**CITY OF BUCKEYE
PLANNING AND ZONING COMMISSION
OCTOBER 12, 2021
AGENDA**

4.A Roers Buckeye Downtown Site Plan (PLZSP-21-00050)
Discussion and Motion (not a public hearing)

- 2R-PLZSP-21-00050 Roers Buckeye Downtown Site Plan REDLINES
- 2R-PLZSP-21-00050 Roers Buckeye Downtown Narrative REDLINES
- 2R-PLZSP-21-00050 Roers Buckeye Downtown Building Elevations REDLINES
- 2R-PLZSP-21-00050 Roers Buckeye Downtown Colors and Site Details
- 2R-PLZSP-21-0050 Roers Buckeye Downtown Landscape Plans (Not for Construction)

A1.3.4

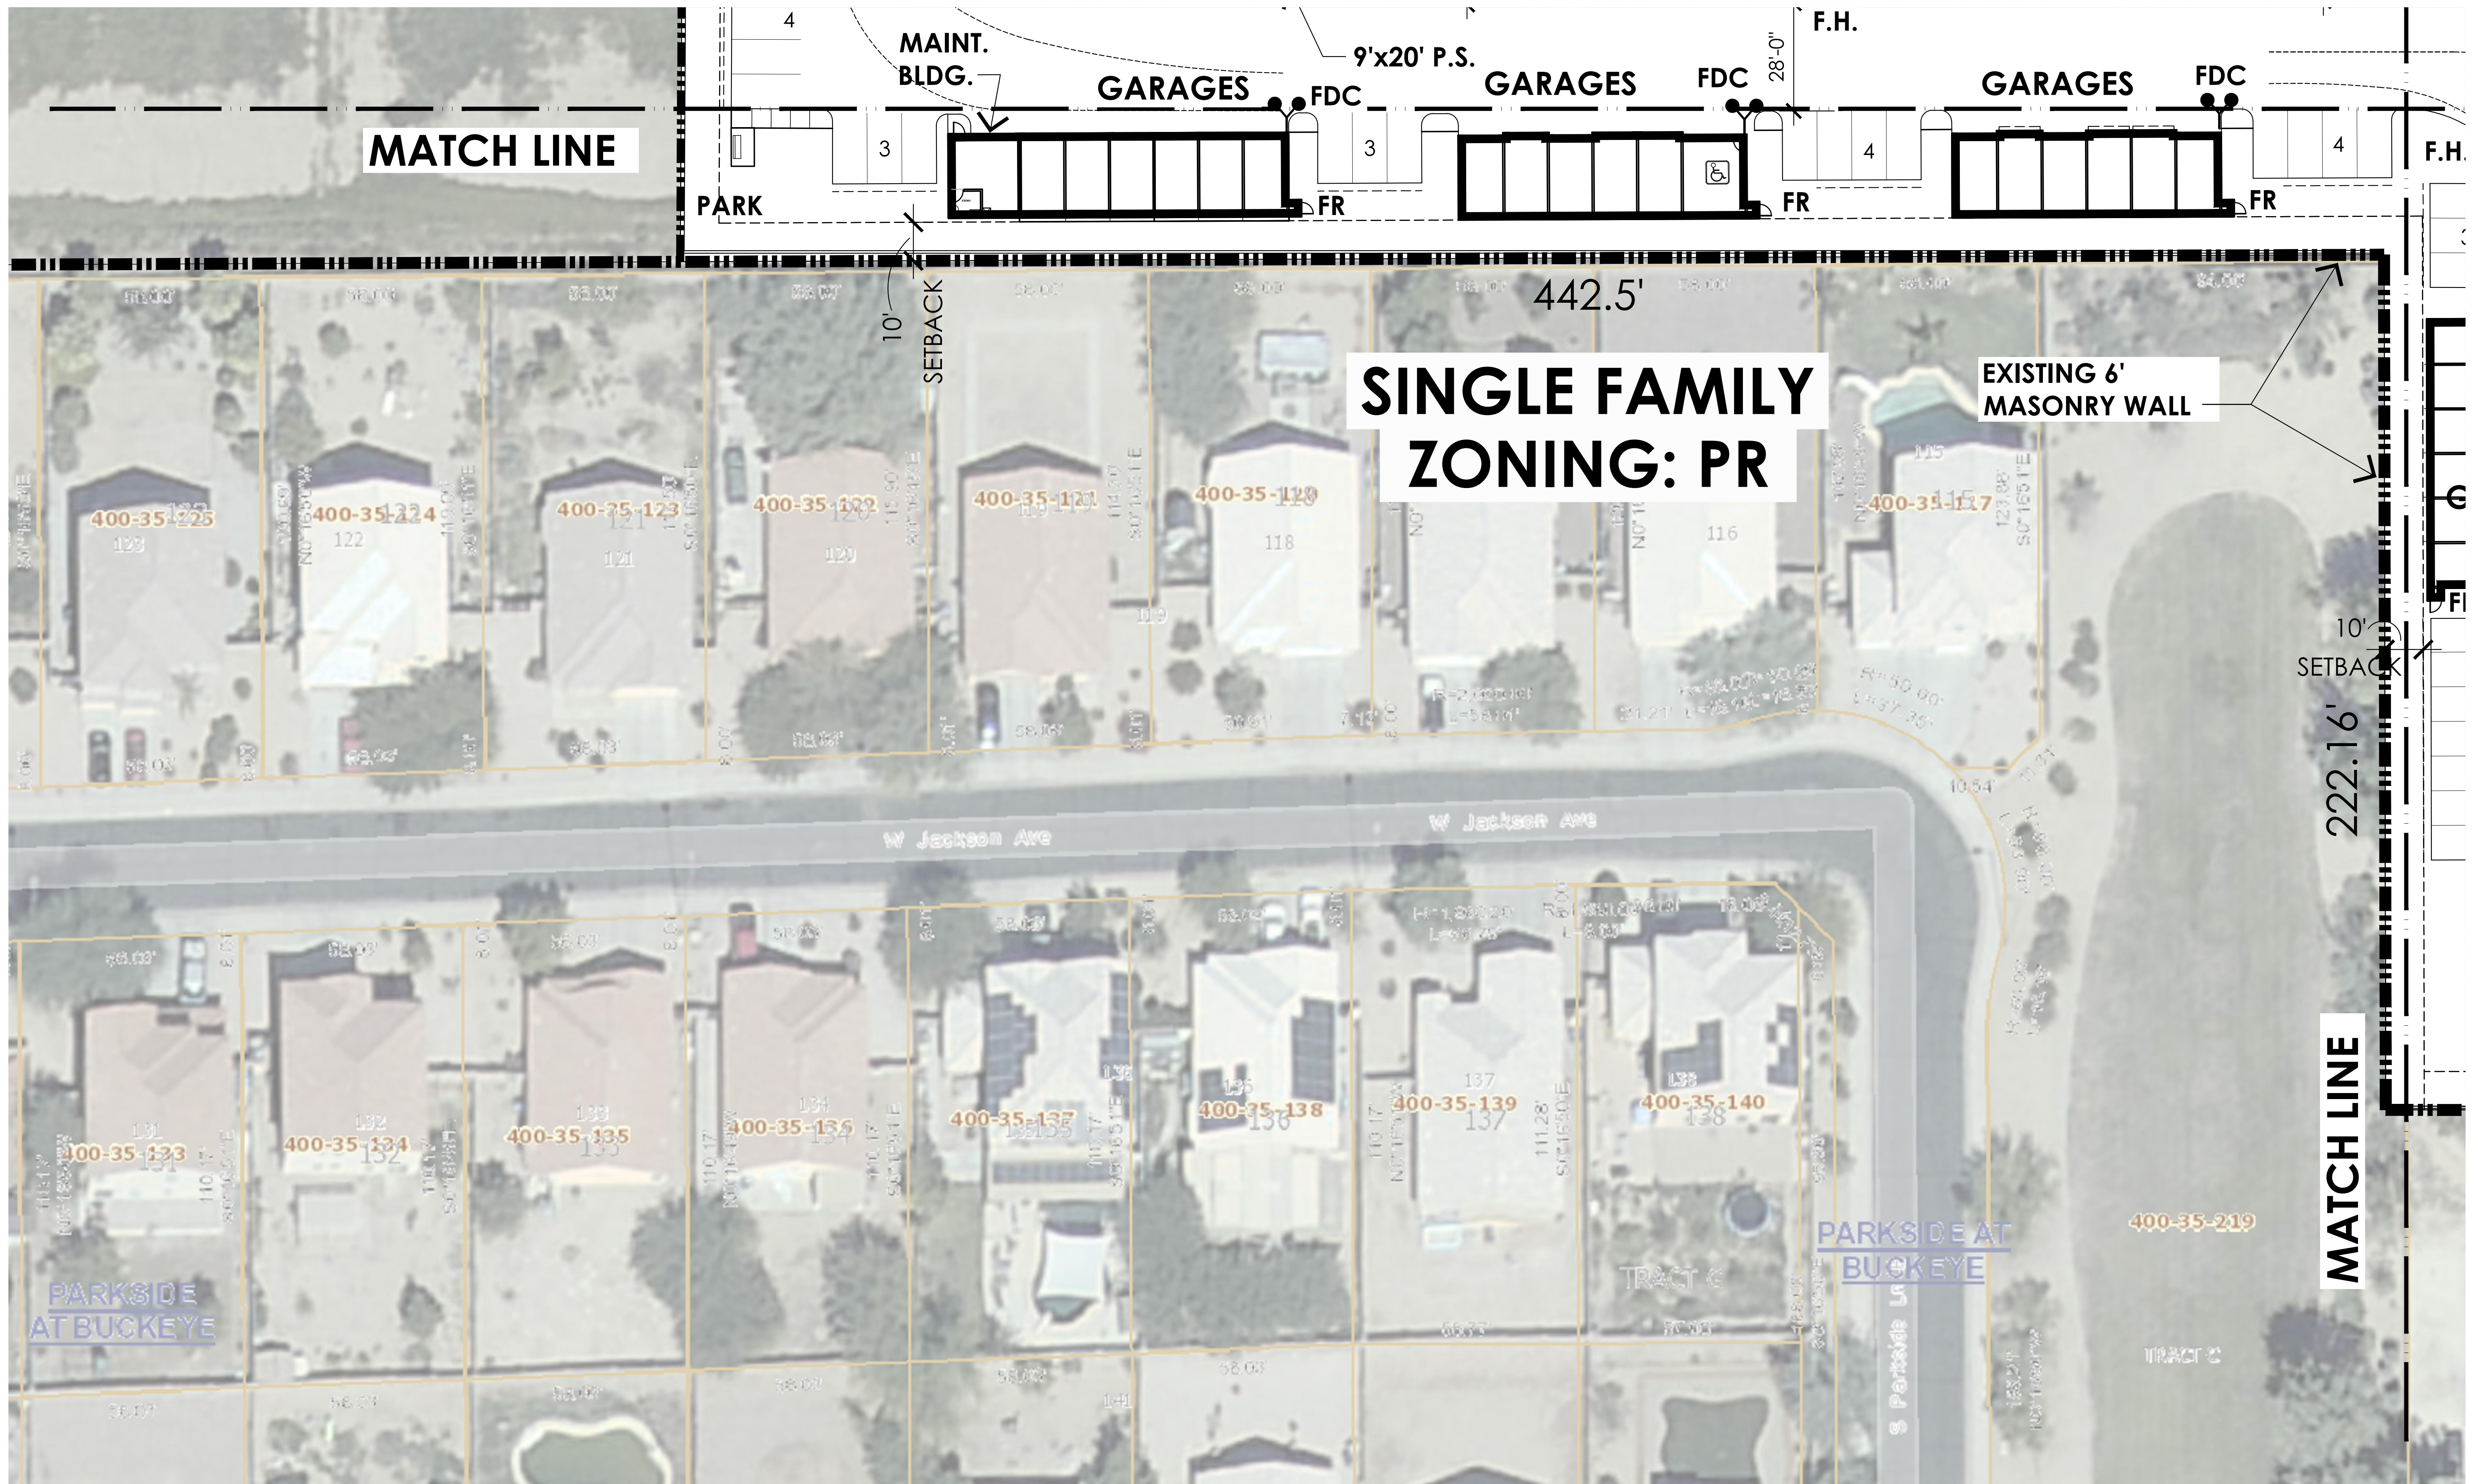
Why was the right turn lane removed?
Dimension right turn lane storage. Verify storage per COB EDS Section 6-3, Table 1 or TIA, whichever is greater.
